# Access Compliance Report

## Public Rights-of-Way

### (Curb Ramps)

Intersection ID: 10253	Main Street: KILDARE_DR	Cross Street: RUTH_DR	Location: SW
ADA ID: 6E6C0B1F8881	Ramp Type: Directional1	Initial Pass/Fail: Fail	Overall Compliance: No
		Severity Score: 1.25

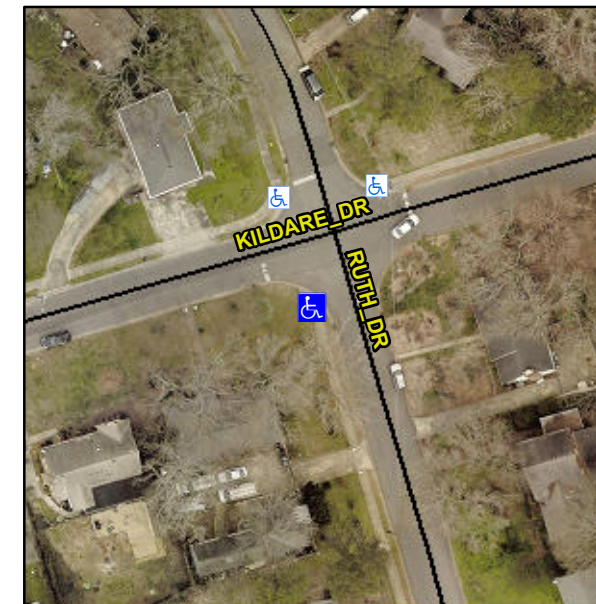
**R304.5.3**

Compliance	Description	Data	Compliance	Description	Data
N/A	Ramp Length (in)	92.0	N/A	Grade Break?	N/A
Yes	Ramp Width (in)	61.0	N/A	Grade Break Slope (%)	0.0
Yes	Ramp Slope (%)	5.1	N/A	Grade Break XSlope (%)	0.0
No	Ramp XSlope (%)	2.5			
N/A	Flare Type LT	N/A	N/A	Flare Type RT	N/A
N/A	Flare Slope LT (%)	N/A	N/A	Flare Slope RT (%)	0.0
N/A	Flare Traversable LT?	N/A	N/A	Flare Traversable RT?	N/A
N/A	Landing Length (in)	0.0	N/A	DWS Provided?	N/A
N/A	Landing Width (in)	0.0	N/A	DWS Contrast?	N/A
N/A	Landing Slope (%)	0.0	N/A	DWS Length (in)	N/A
N/A	Landing X Slope (%)	0.0	N/A	DWS Full Width?	N/A
N/A	Landing Curb? (Y/N)	N/A	N/A	DWS Offset LT (in)	N/A
N/A	Shared Landing?	N/A	N/A	DWS Offset RT (in)	N/A
N/A	Gutter Ponding?	0.0	N/A	Gutter Slope (%)	N/A
N/A	Gutter Lip Ht (in)	0.0	N/A	Gutter X Slope (%)	N/A
N/A	Painted X Walk1?	No		Road Slope (%)	0.7
	X Walk 1 Direction	To NW		Road X Slope (%)	1.4
	X Walk 1 Width (in)	N/A		Clear Space?	N/A

**Remove & Replace Entire Ramp.**
